Re: Addendum No. 1
Youngstown-Lowellville Road Storm Sewer Improvements
Village of Lowellville

Date: December 10, 2024

REPAIR AND REPLACEMENT OF CONCRETE APRON DETAIL

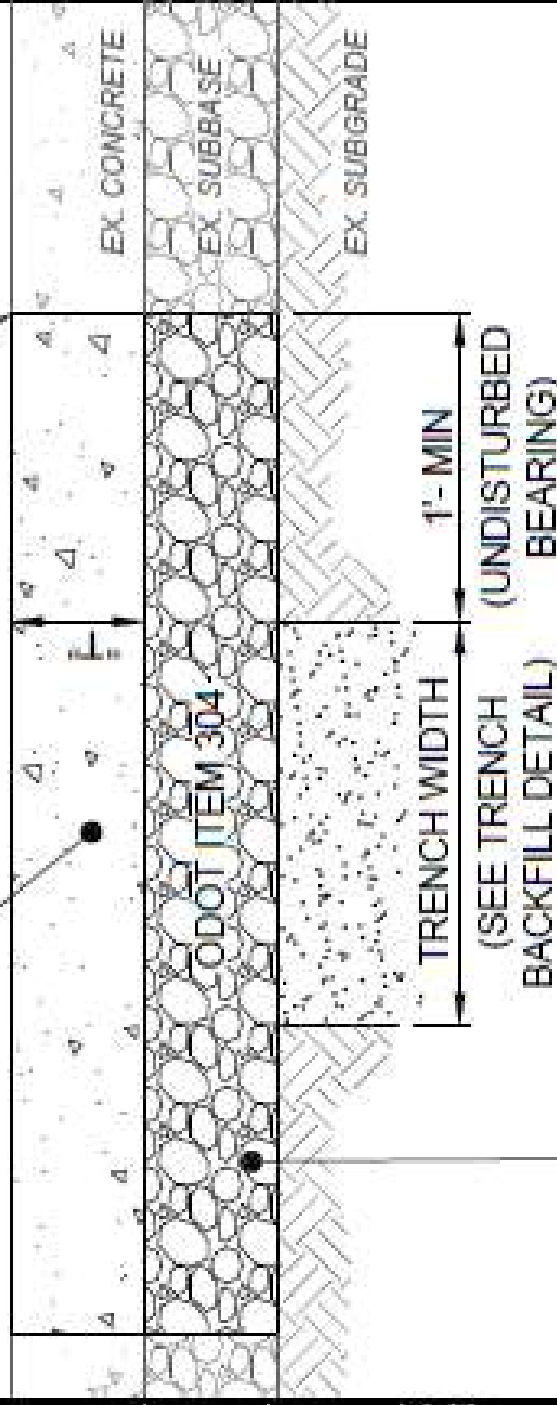
Sheet 4:

Type “A” Concrete Driveway Replacement detail has been included in this Addendum.
